Staff Report & Recommendation

Historic Preservation Board

SUBJECT: HPB18-0252, **355 19th Street.**

The applicant has submitted plans entitled "Park Avenue Hotel" as prepared by Revuelta Architecture International, dated June 4, 2019.

Original south elevation drawing, Microfilm #36867

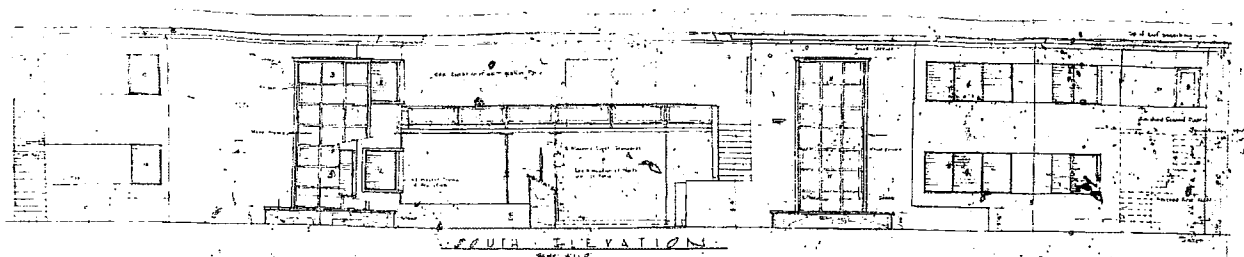
The existing 2-story apartment building, only minimally altered, is capable of having most, if not all of its significant architectural elements restored. These features include an elevated pedestrian walkway, decorative scored stucco, exterior catwalks, projecting eyebrows, projecting window frames, raised stone clad planters, bean poles, projecting eaves and a courtyard plan, all characteristics which are representative of the Post War Modern Garden style of architecture in Miami Beach. Further, the existing building contributes to a clear

Contrary to this statement, staff believes that restoration of the above mentioned features of the existing building, in combination with the reintroduction of the original screening elements and courtyard railings, as seen in the image on the following page, could be successfully accomplished in a manner which highlights this excellent example of low-scale Post War Modern multifamily residential architecture.

- c. The proposed new elevated pedestrian walkway shall be substantially consistent with the design of original elevated walkway, and shall include railings inspired by the original pipe and canvas railing design, in a manner to be reviewed and approved by staff consistent with the Certificate of Appropriateness Criteria and/or the directions from the Board.

- d. The original screening elements located on the east and west wings shall be reintroduced, consistent with available historical documentation, in a manner to be reviewed and approved by staff consistent with the Certificate of Appropriateness Criteria and/or the directions from the Board.

- f. All exterior architectural features located on the southern portions of the building to remain shall be fully restored and/or reintroduced, consistent with available historical documentation, in a manner to be reviewed and approved by staff consistent with the Certificate of Appropriateness Criteria and/or the directions from the Board.
